N. Mel Waiters Way 24-Inch Water Main Replacement
Solicitation Number: CO-00228
Job No.: 16-4011

ADDENDUM 1
December 21, 2018

MAP No. _____	SHEET 2
SECT. No. _____	
DR. _____ CK. _____	JOB No. 16-4011
Of 30

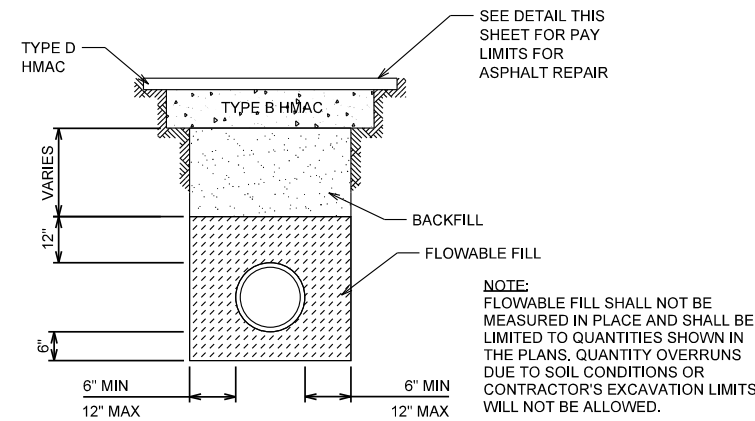
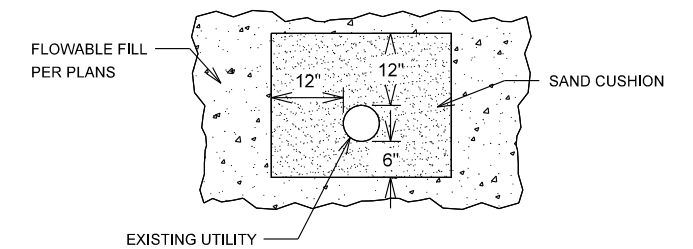
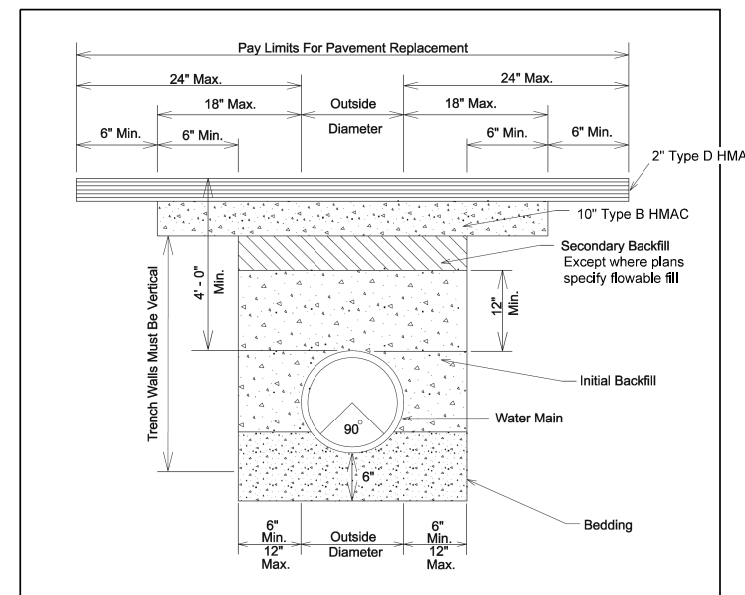
- 11. Question:** Bore pit at STA 26+70 since the waterline is in the bore pit, can this waterline be removed.
Response: Existing 24-inch water main will be shut down during construction of bore pit at STA 26+70 and can be removed as needed within footprint of bore pit. Reference "Proposed Construction Phasing" notes on sheet 2.

- 13. Question:** Note 1 Phase 1: on sheet 2 of 30 shows a date of 4/30/19 for completion of this first phase. When is the anticipated date to start for this project? Bores will take about a month to complete before any of the main is installed. Please give enough time to complete the bores.

Response: Anticipated NTP for this project is late March 2019. See revisions to sheet 2 included in this addendum.

DEVELOPER:		BUDGET PROJ.	
SUBMITTED		APPROVED	
MAP No.	SECT. No.		SHEET
DR.	CK.	JOB No. 16-4011	22
			OF 30

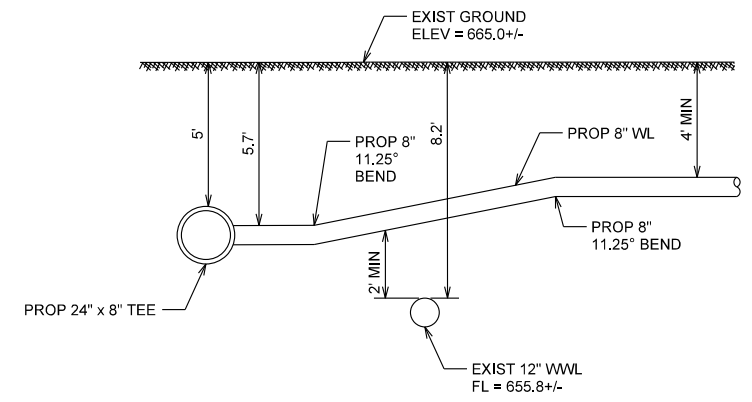
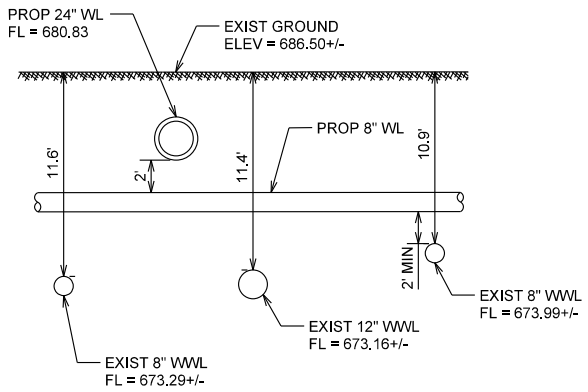
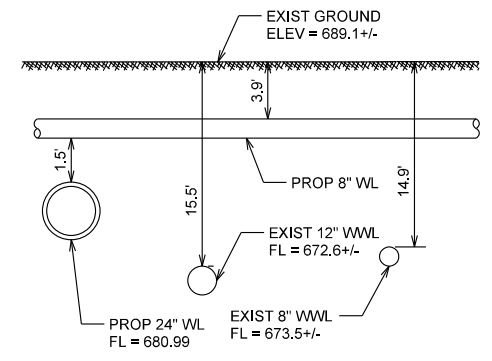
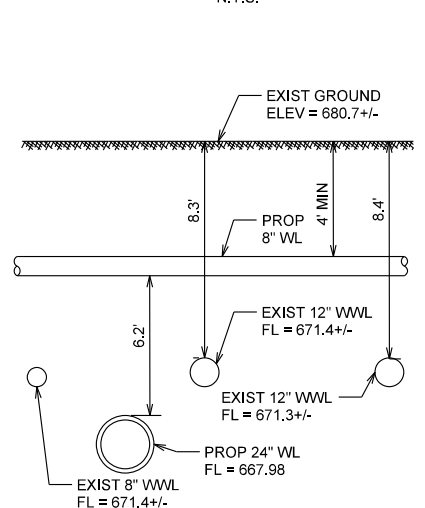
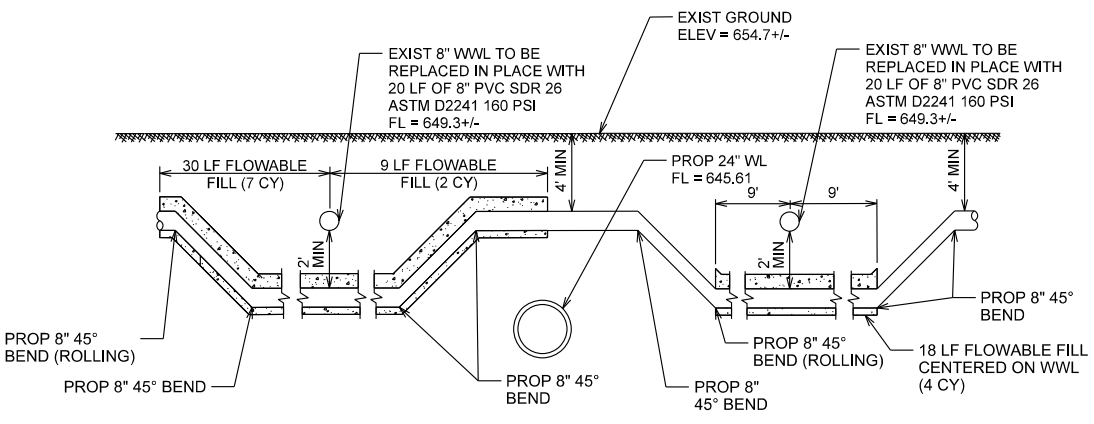
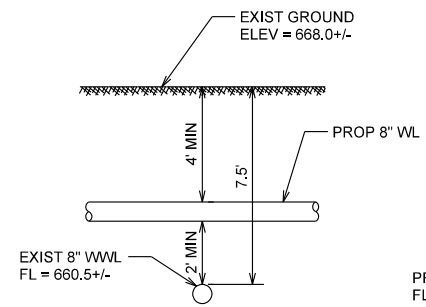
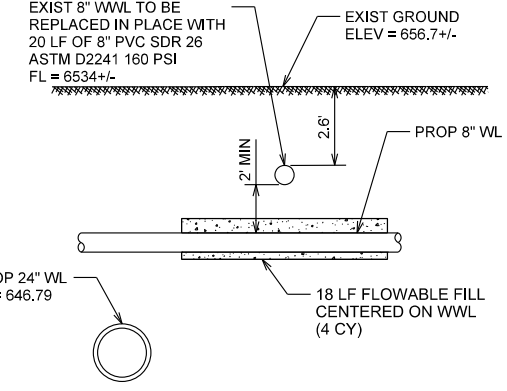
- 12. Question:** STA 18+75 there is an existing 8in CI at exit bore pit, can this line be removed or a temporary waterline be required?
Response: As noted on sheet 9, existing water main can be removed. No temporary waterline is required at this location. Refer to revised sheet 22 indicating main can be removed.
